Development Permit Panel Electronic Meeting

1. **DEVELOPMENT PERMIT 21-945917**

APPLICANT: Arno Matis Architecture

PROPERTY LOCATION: 6851 and 6871 Elmbridge Way

DRAWING TITLE: **GROUND LEVEL** LANDSCAPE PLAN

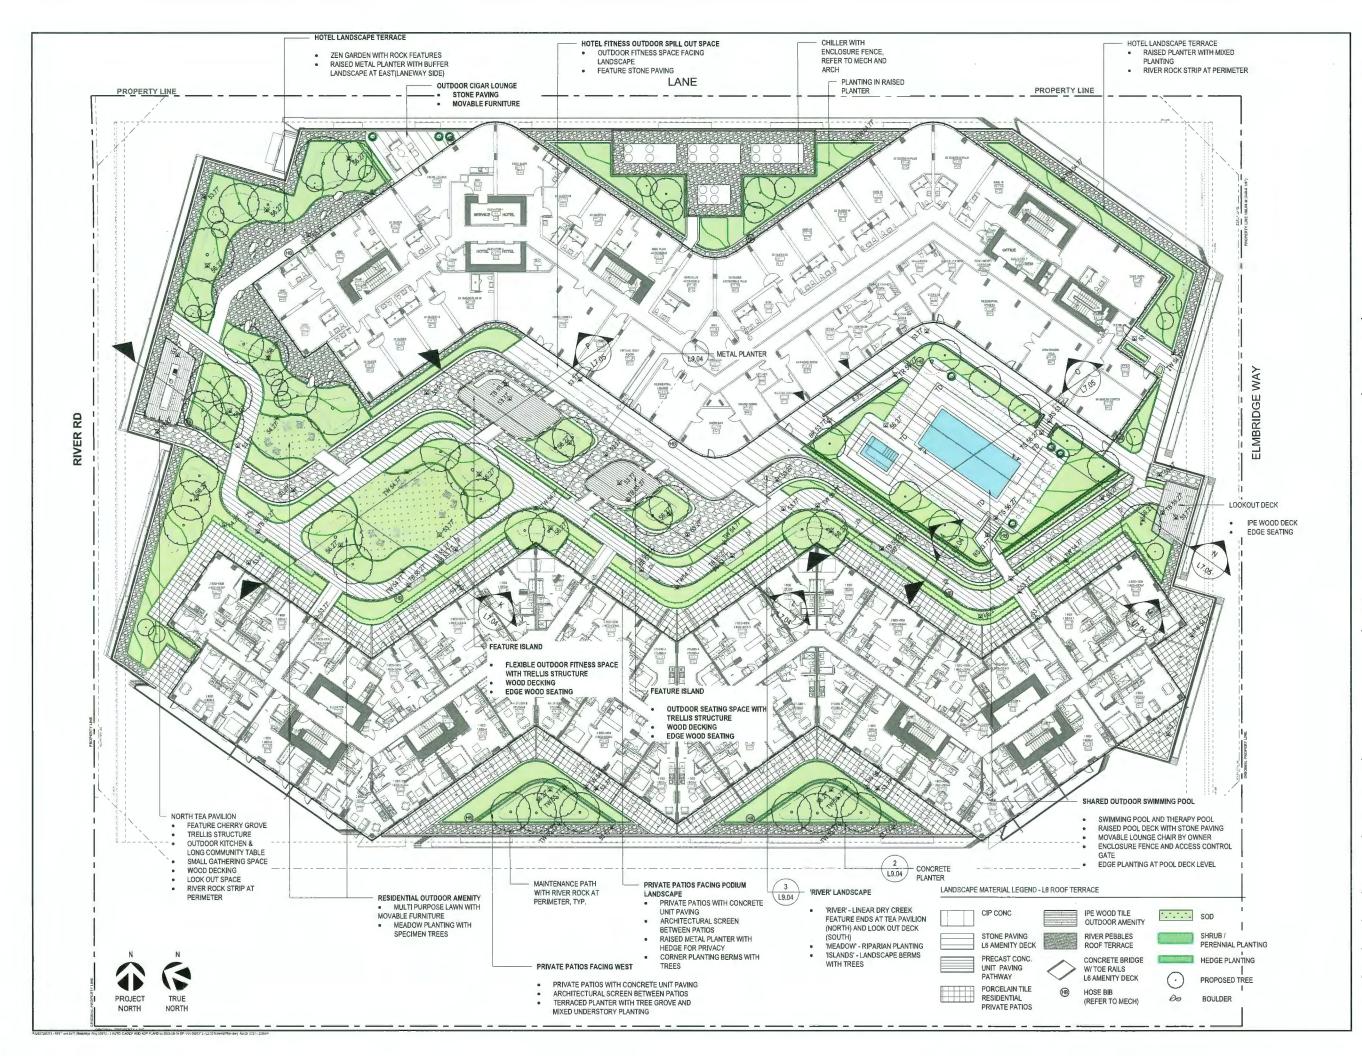
- The north side ploza works well; however, the proposed stairs on the south plaza are long; look at the neighbouring
 Ora development on their approach to grade transition and investigate opportunities to reduce the scale of the stairs
 and incorporate additional landscaping to help soften the Elmbridge Way frontage; RESPONSE FROM LANDSCAPE
 ARCHITECT: The stairs along Elmbridge Way have been reduced in scale by doubling planted segments. Additional
 planting has been incorporated to soften the grading. Please refer to drawing L2.01 Ground Level Landscape Plan.

- Consider moving the location of the accessible ramp at the southeast corner onto the laneway to soften the grade transition from Elmbridge Way; RESPONSE FROM LANDSCAPE ARCHITECT: The accessible ramp has been relocated

to the laneway with the entry point facing the Elmbridge Way. Please refer to drawing L2.01 Ground Level Landscape Plan.

DRAWING TITLE: **GROUND LEVEL**

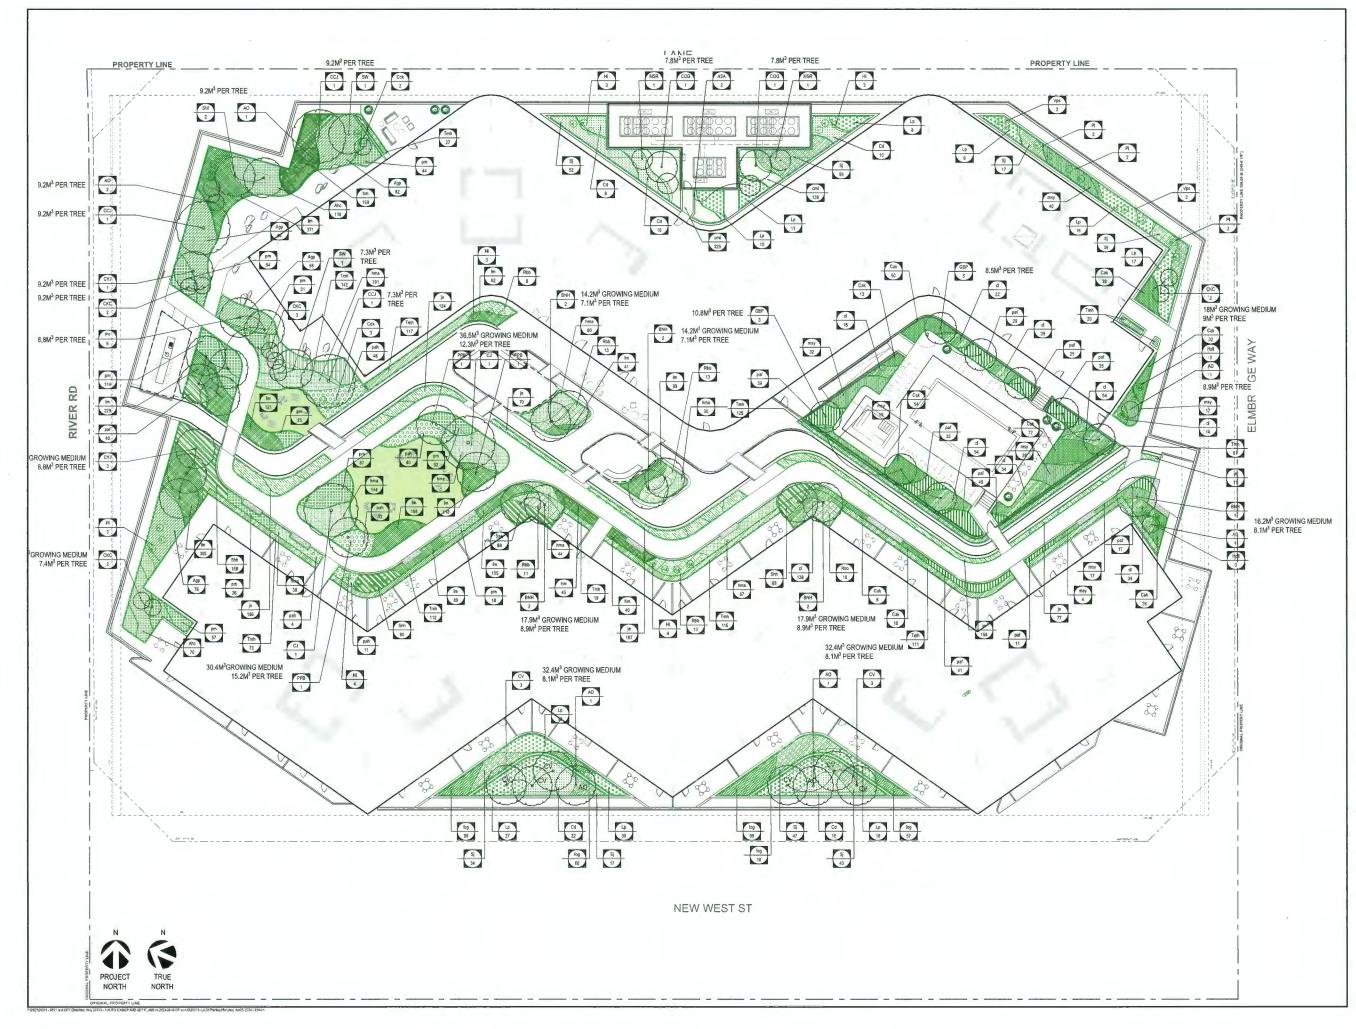
- Planters ot Elmbridge Way and New West Road appear to be too small for trees indicated: consider aiming for a
 minimum of 6 cubic metres of soil volume even for smaller trees; and RESPONSE FROM LANDSCAPE ARCHITECT: A
 minimum of 6 cubic meters of soil has been provided for each on-site tree in planter at Elmbridge Way and New
 West Road. Please refer to drawing L4.01 Ground Level Planting Plan for the proposed soil volume for trees.
